11.5 Utility Correspondence

RBF Consulting (RBF) has been contracted by the Town of Mammoth Lakes to prepare an Subsequent Environmental Impact Report (SEIR) for the Inn at the Village Project and I had a question for you regarding fire flow requirements for the project:

Re: Comments on Modified Initial Study/Environmental Checklist

DRIVEWAY MAP FOR MINARET ROAD
ENTRANCE/EXIT

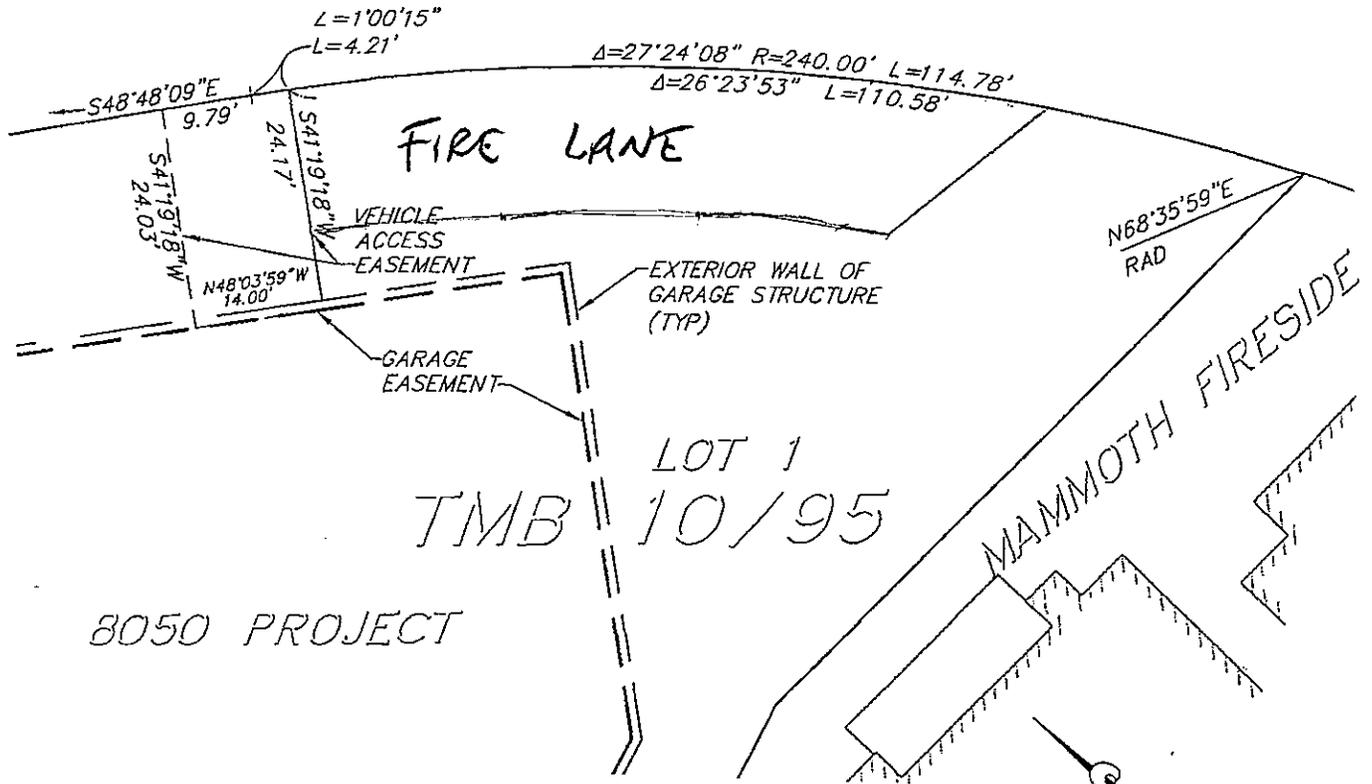
The Fire District shall require that the project proponent provide a fire lane on Minaret Road that is 60 feet by 16 feet in size. This area shall be outside of any drop off/loading area or driveway and located in the vicinity of the southeast corner of the structure (diagram attached). The lane shall be maintained and be part of the project's snow removal responsibilities.
